Technical Bulletin

GS Series 555 projector classification 3R

Class 2 laser label

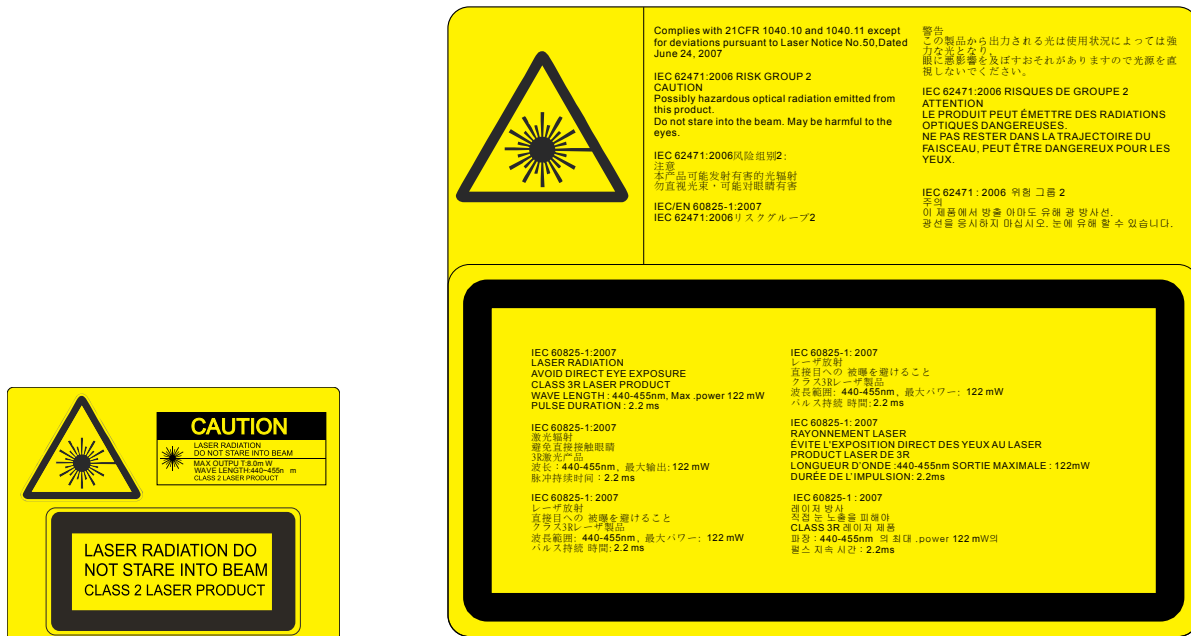
The DHD555-GS, DWU555-GS, and DWX555-GS projectors become laser Class 3R according to IEC 60825-1:2007 when the 2.90-5.50:1 Zoom G lens is installed.

To meet IEC 60825-1:2007 standard requirements when these projectors are used with this lens, Christie has taken immediate action to provide new labels and replacement instructions to affected customers to relabel the product according to IEC 60825-1:2007 as Class 3R Laser radiation. Below are the label samples that show the difference between a Class 2 and Class 3R laser product.
